SERIAL: BSEP 01-0104
TSC-2001-11

BRUNSWICK STEAM ELECTRIC PLANT, UNIT NO. 1
DOCKET NO. 50-325/LICENSE NO. DPR-71
REQUEST FOR LICENSE AMENDMENT
REVISION OF MINIMUM CRITICAL POWER RATIO SAFETY LIMIT VALUES

Basis For Change Request

Figure 1 Reference Core Loading Pattern – Cycle 13

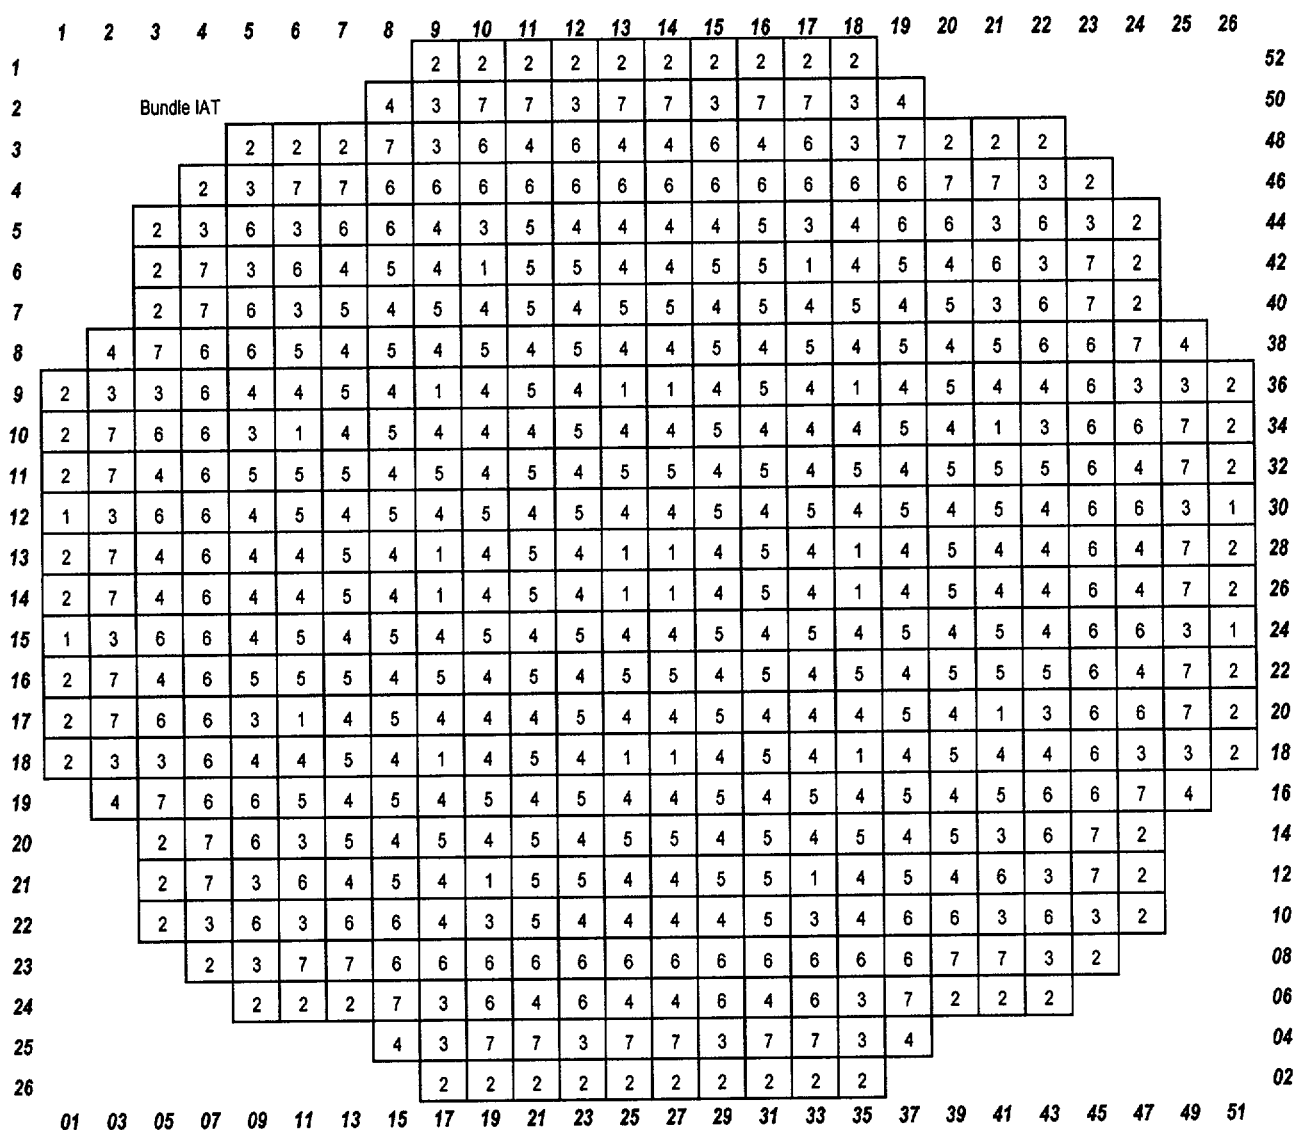
1. Provide the fuel types and numbers of assemblies used in Brunswick Unit 1 Cycle 14 operation and identify if they are fresh or irradiated fuel (once or twice burned, etc.). Also, provide the fuel loading pattern for Cycle 14 and identify its difference from Cycle 13 and the impact on the SLMCPR calculation.

The requested core loading information is provided as Figures 1 and 2. The impact of the fuel loading pattern differences on the calculated SLMCPR is correlated to the values of [[
